Carlton Residents Association Inc

Submission 10 April 2018

Amendment C320 to the Melbourne Planning Scheme 154-160 Leicester Street, Carlton - SITE OF THE FORMER CORKMAN IRISH PUB

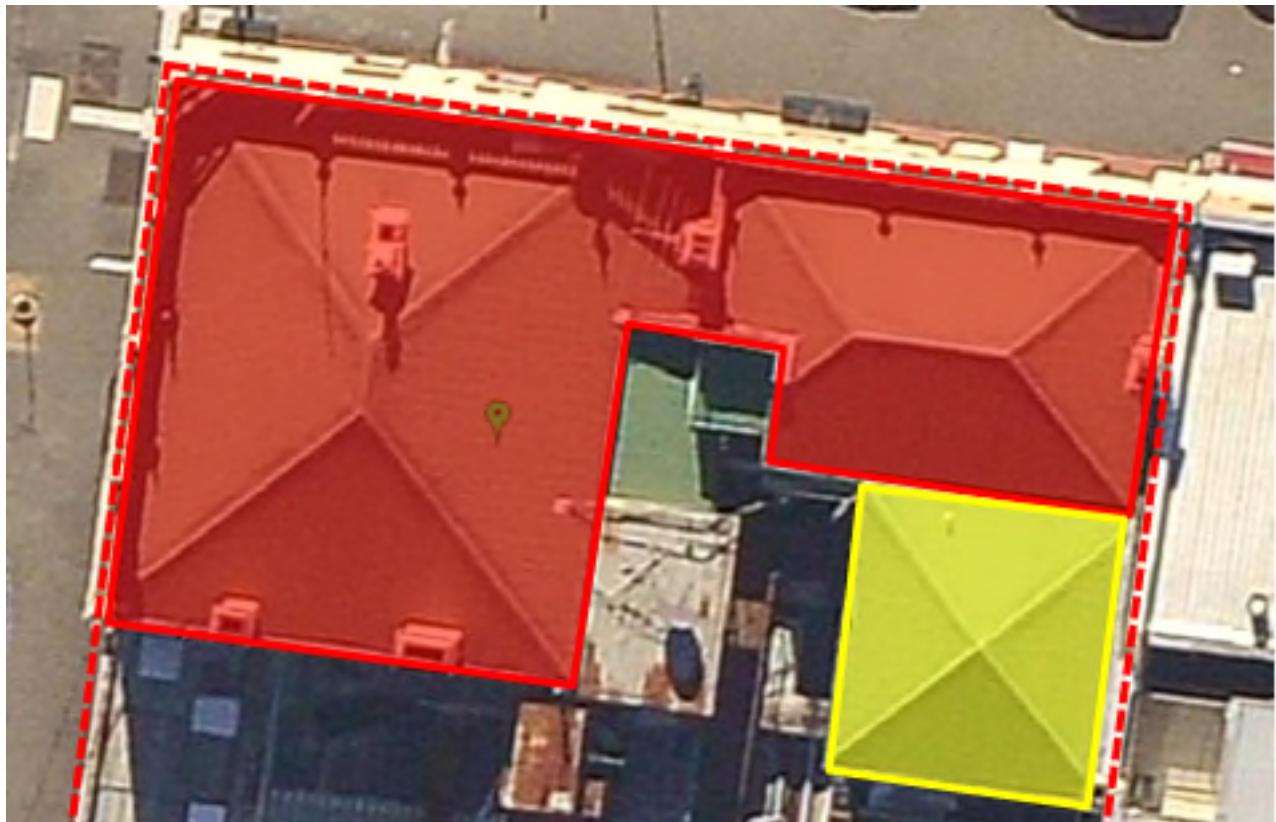
In the opinion of the Heritage Consultant, all of the 19th Century Heritage fabric [shown in red] should be reconstructed. The heritage fabric constructed in 1936 [shown in yellow] could be reconstructed. [See image extracted from the Consultant's Report]. That is, heritage fabric to a depth of about 7 metres on Pelham Street and about 9.6 metres on Leicester Street should be reconstructed.

More particularly, the key elements of the external fabric which the heritage consultant recommended should be reinstated, included the following:

- Hipped roof form, clad in corrugated sheet metal (the roof had a green finish – painted or powdered coated)
- Chimneys with moulded cappings, 3 to perimeter and 2 penetrating
- Parapet – bottle balustrade, with signage to west corner and orbs surmounted by finials

That is, the extent of reconstruction recommended by the heritage consultant [to a depth of 7 to 9.5 metres from Pelham and Leicester Streets respectively] falls well within the guidance of the proposed new policy.

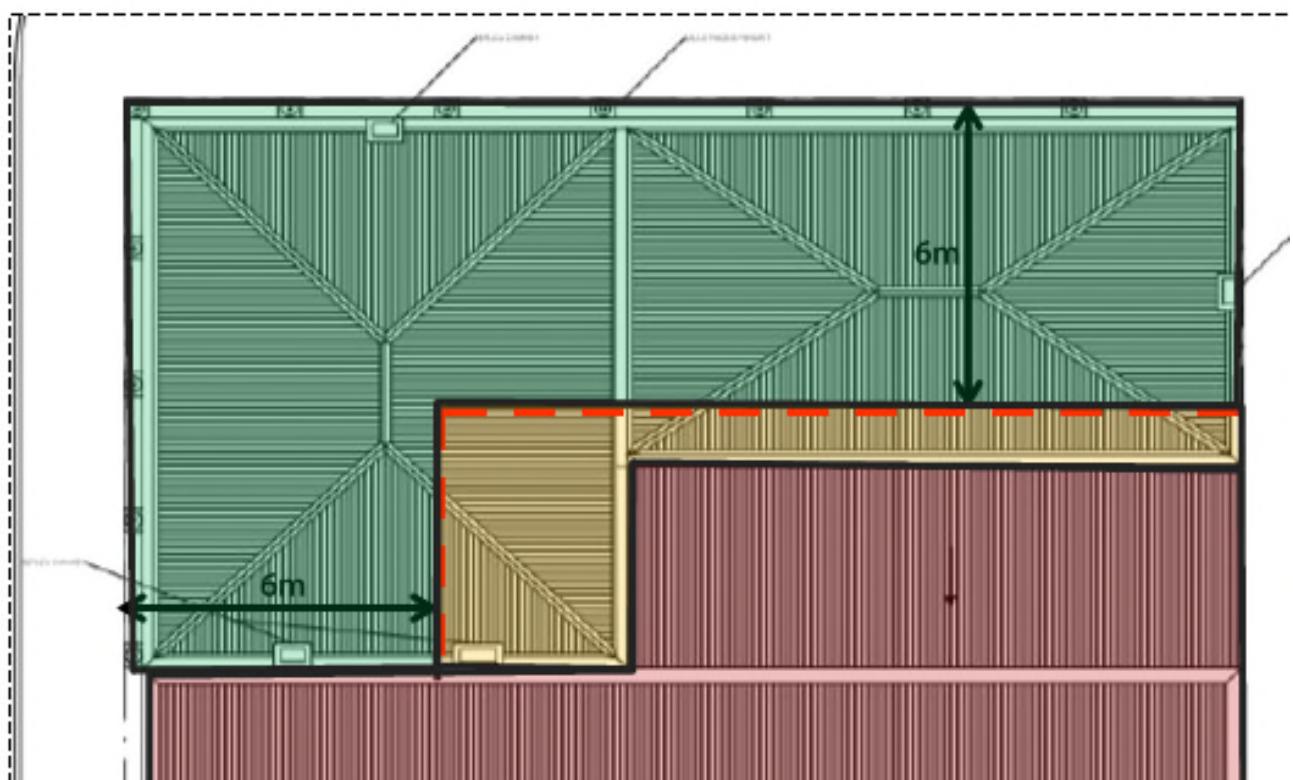
In contrast, the Planning Consultant has recommended [and the Council has agreed] that the DDO61 setback of 6 metres [above the reconstructed heritage building] should define the extent of reconstruction that is required. That is, if the heritage place had not been demolished, the Council is acknowledging that significant heritage fabric could be demolished [see image below, extracted from the Planning Consultant's Report].

It must be emphasised that the DDO61 setback of any part of a building above the street edge height is intended to deliver “a scale of development that provides street definition and a high level of pedestrian amenity, having regard to sunlight, sky views and a pedestrian friendly scale.” That is, this provision is to be applied even where there are NO heritage places. In the view of the CRA, the presence of a significant heritage context should result in any setback guidance being modified to give greater weight to key heritage objectives.
